STAFF REPORT
COMMUNITY DEVELOPMENT DEPARTMENT

HEARING DATE: 5/4/2021
TO: Mayor & City Council
FROM: Alan Tiefenbach, Associate Planner
208-489-0573
SUBJECT: FP-2021-0017
Tetherow Crossing Final Plat
LOCATION: The site is located northeast of N. Linder Rd and W. Ustick Rd

Final plat consisting of 46 buildable lots and 8 common lots on 7.58 acres of land in the R-8 zoning district, developing in a single phase.

B. Final Plat (date: 2/17/2021)

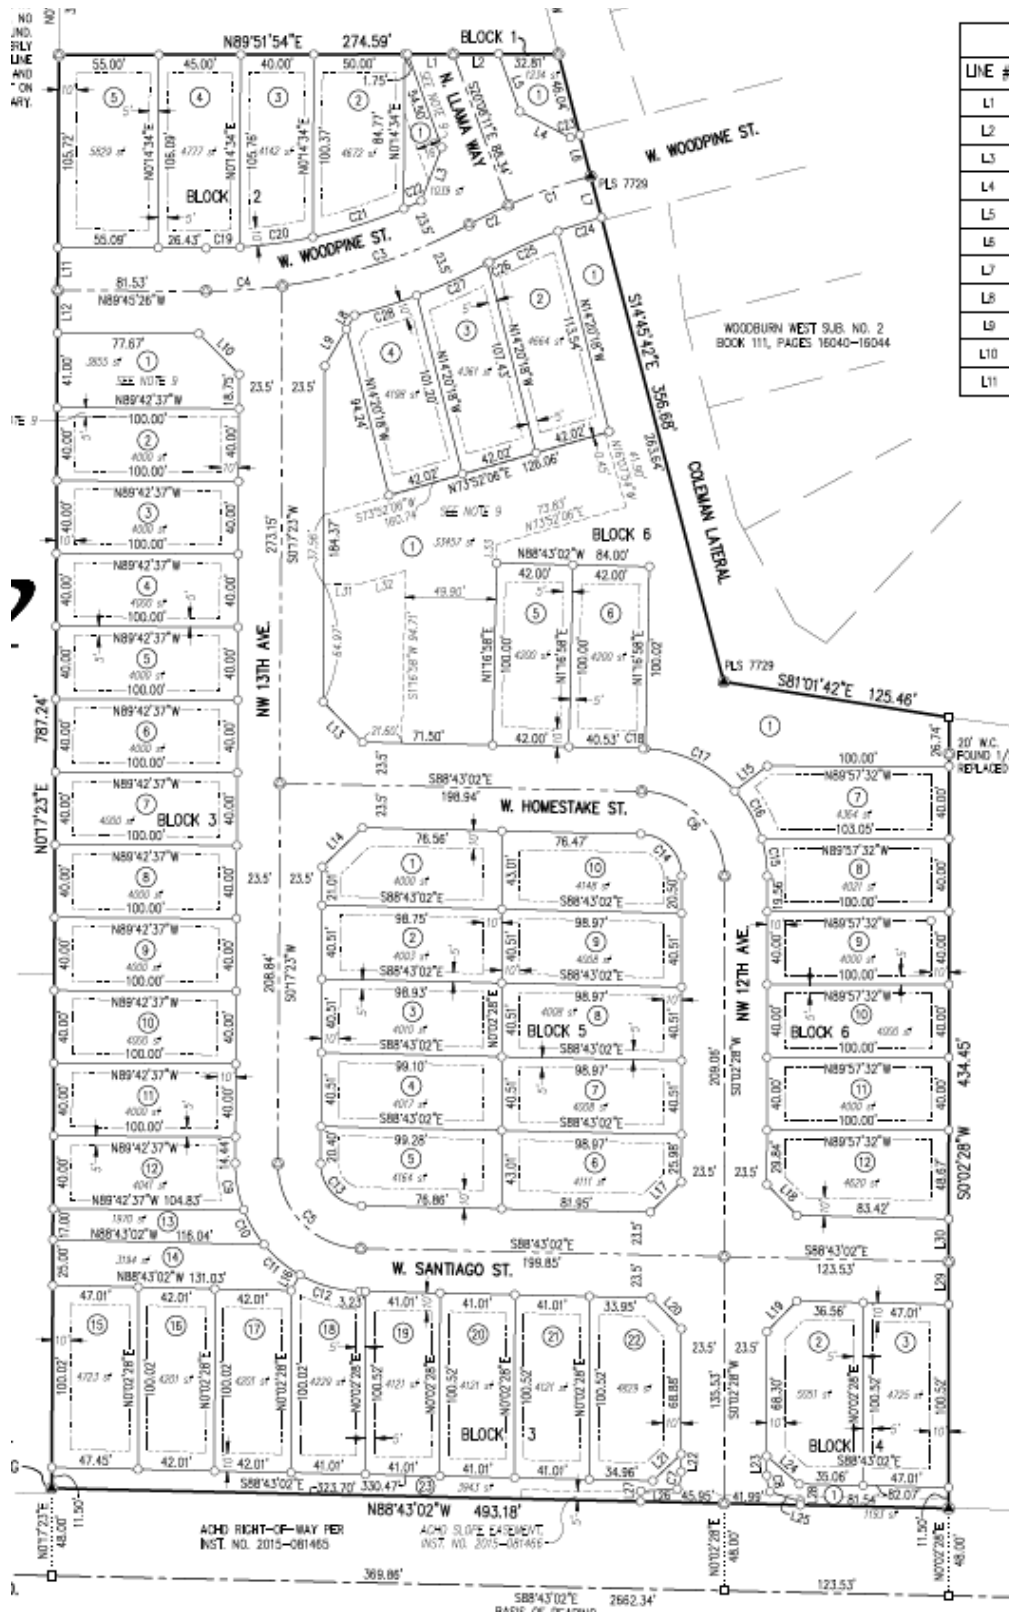
3. Prior to City Engineer signature on the final plat, the final plat prepared Land Solutions, stamped by Clint W. Hansen, dated: 02/17/2021, included in Section V.B shall be revised as follows:

- a. Add a note that Lots 2-5, Block 2 are limited to one story.
 - b. Note 12, add Instrument Number.
 - c. Note 13, add ACHD Instrument Number.
4. The landscape plan prepared by Jensen Belts Associates on February 17, 2021 is approved as submitted.
